UNITED STATES PATENT AND TRADEMARK OFFICE

APPLICATION NO.	FILING DATE	FIRST NAMED INVENTOR	ATTORNEY DOCKET NO.	CONFIRMATION NO.
10/797,258	03/09/2004	Pankaj Mehra	200314264-1	5351

Office Action Summary	Application No. 10/797,258	Applicant(s) MEHRA ET AL.	
	Examiner Cheryl Lewis	Art Unit 2167

Fig. 3

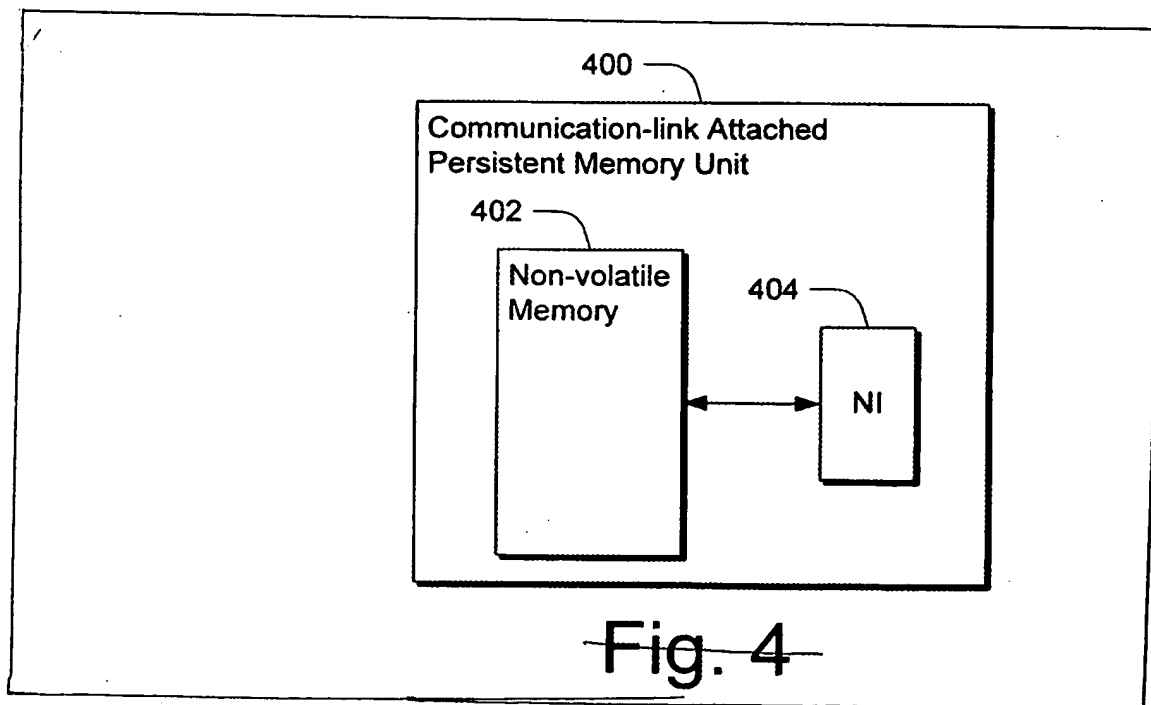
3. The drawings are objected to because drawing figures 3 and 4 depict a partial view of the drawing figures. A box and/or a line drawn around each individual drawing figure is needed to show each individual figure as a separate entity (MPEP 37 CFR 1.84(h)).

As a convenience to the applicants, the examiner has attached an amendment of drawing figures 3 and 4 to show by example, how to effectively amend drawing figures 3 and 4.

~~Fig. 3~~

~~Fig. 4~~

Fig. 4
